AGENDA
CITY PLANNING COMMISSION

DETAILED DEVELOPMENT PLAN - The applicant, DEC LAND CO I, LLC, is requesting approval of a Detailed Development Plan for Section 6, Phase VI and Phase VII of the Carriage Trails Development (ZC 21-05).

Subject: ZC 21-05 (Detailed Development Plan Carriage Trails Sec. 6, Ph. VI & VII)

Huber Heights Fire Division

SHEET NO.: 1/3

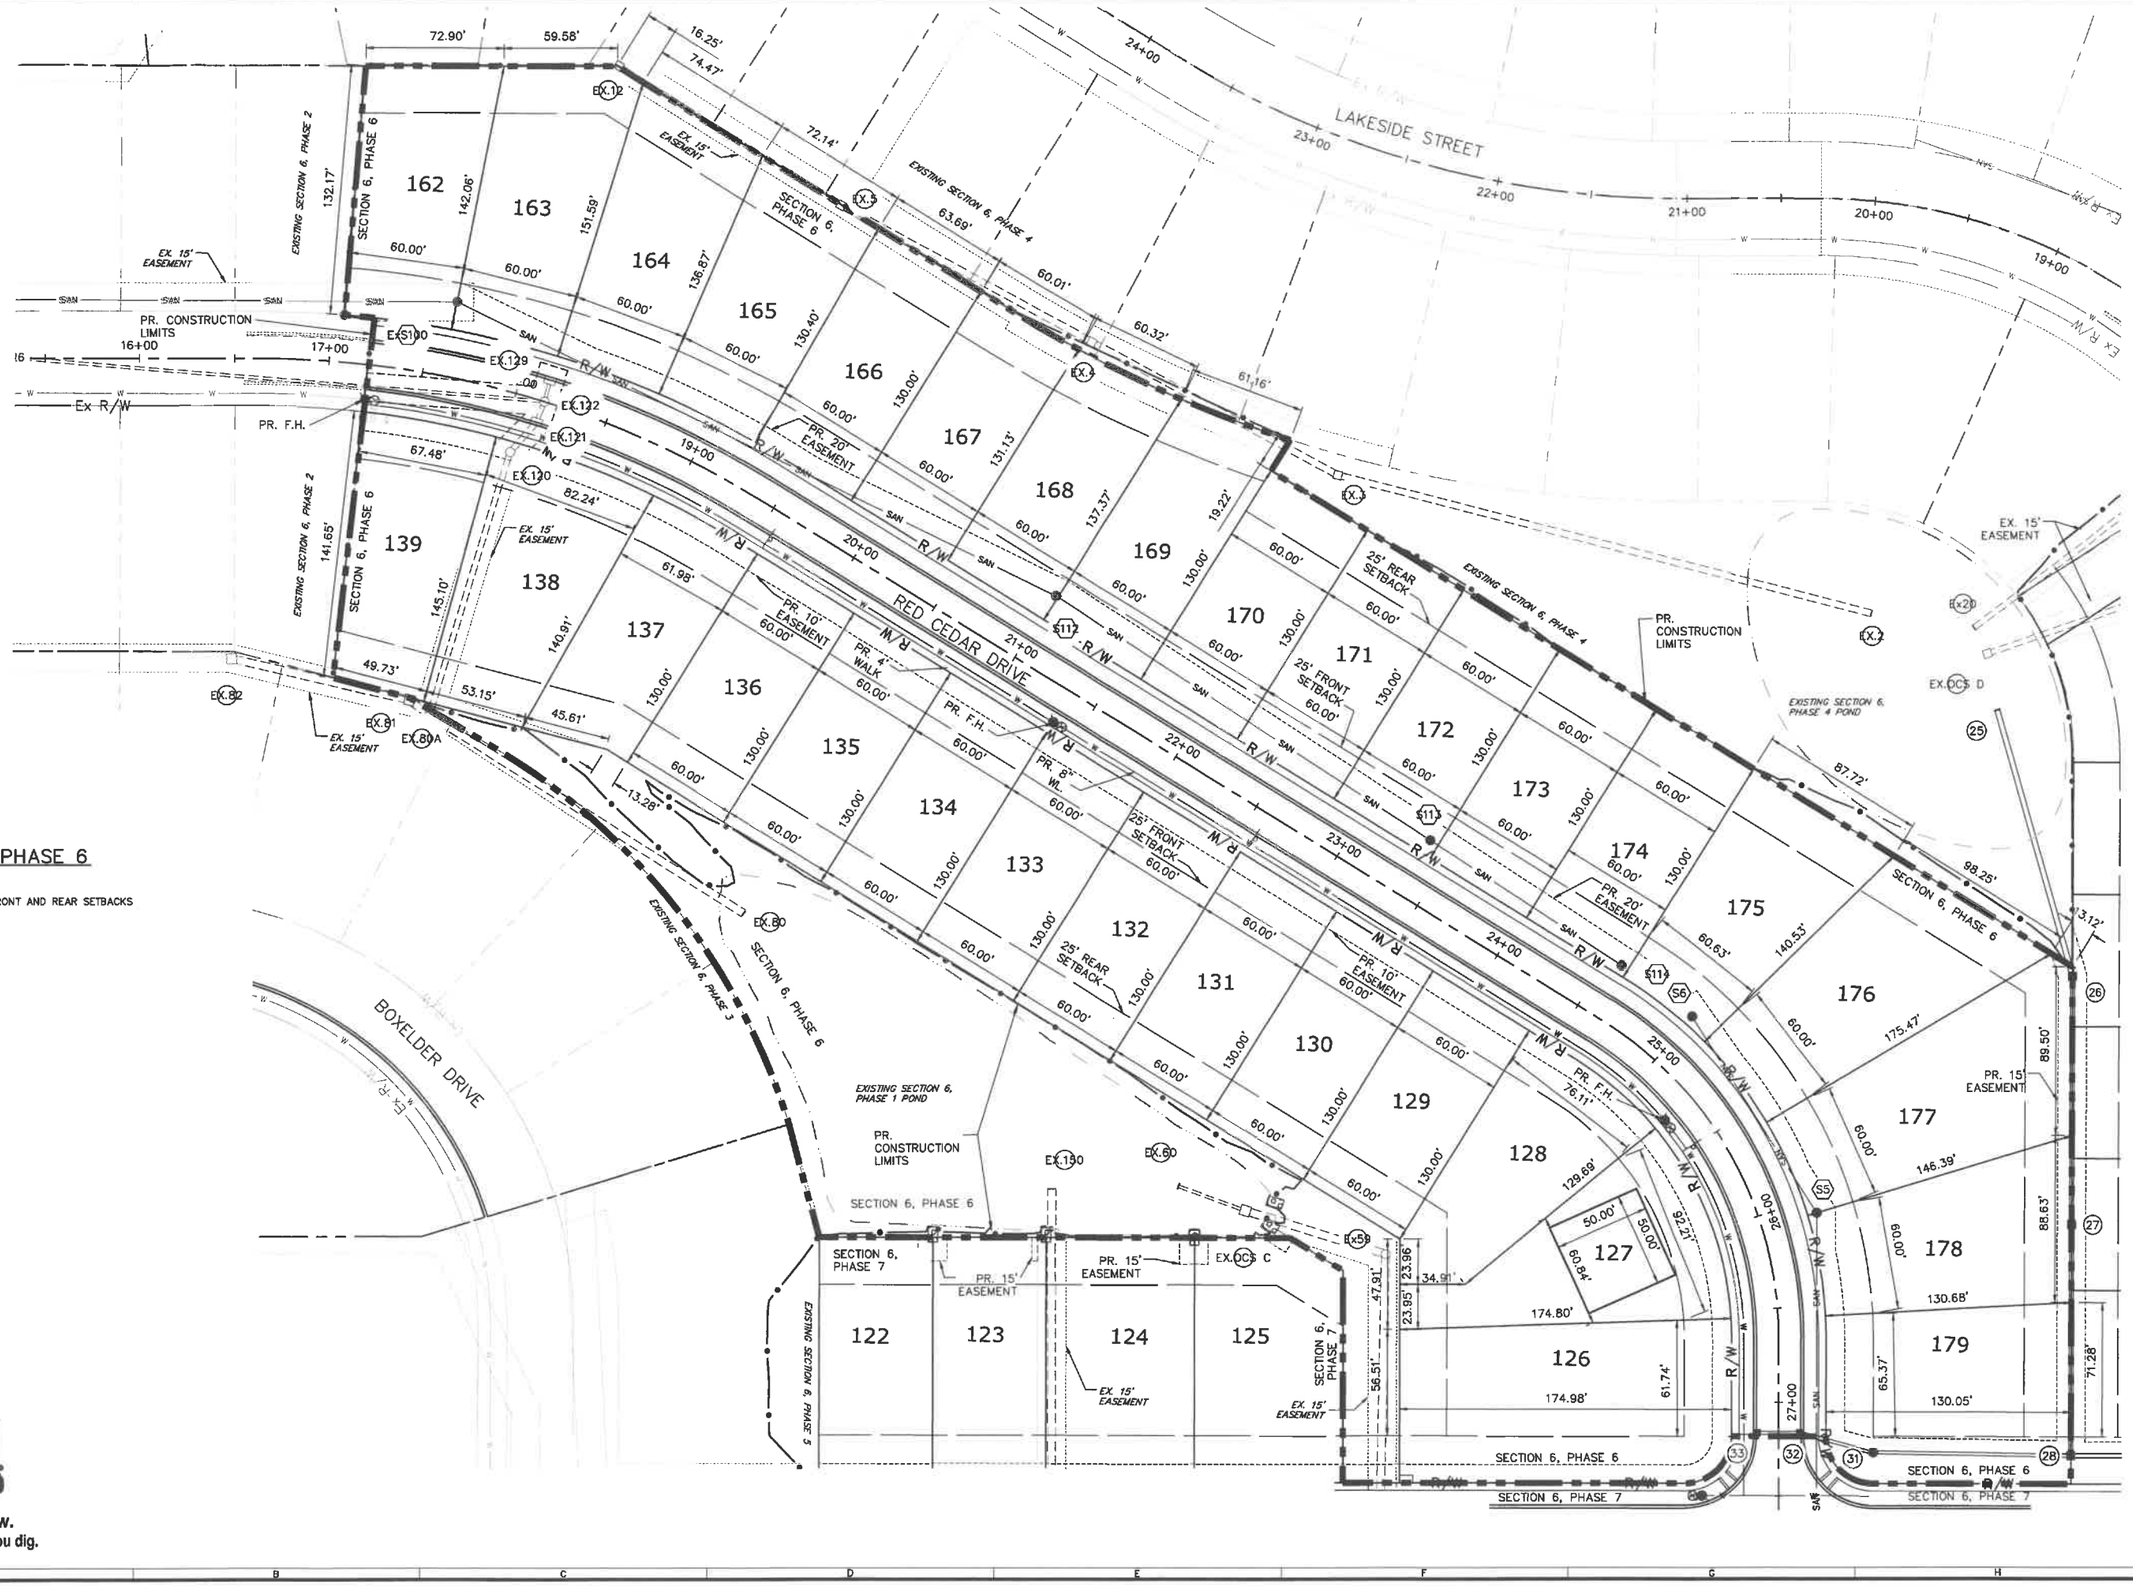
After reviewing the lot sizes of the southern neighboring properties, the southern lots will be required to be 70 feet wide or wider. This condition affects lots 31 through 50 and 199, which comply with the lots having widths of 70 feet.

The southern property line has a line of mature trees. There are some dead that will be required to be removed. The Developer has agreed to save as many existing living mature trees as reasonable.

This Section also makes a connection to Trowbridge Way to the south. All construction traffic shall come from within the Carriage Trails development and not from the existing neighborhood to the south.

- **Fire Hydrants: Hydrants shall be spaced no greater than 500 feet apart and within 400 feet from any opening in any building. Please confirm locations.**
- **In accordance with Huber Heights Codified Ordinance 1521.06 (b)(1), "The Fire Code Official shall make a determination if a double Storz hydrant is needed in residential areas with single family homes greater than 3600 square feet." If homes in this area exceed 3600 sq. ft. please advise.**

- **2017 Ohio Fire Code: 503.2.1 and 503.4 fire lanes shall maintain a width of 20 feet exclusive of shoulders, and cars cannot be parked to obstruct that 20 feet width. Consider fire lane on one side of street to meet 2017 Ohio Fire Code. (The recommendation is to place the "No Parking Fire Lane" signage on the side of the street with Fire Hydrants).**

3. No construction traffic shall use Trowbridge Way except for utility work on Trowbridge Way.
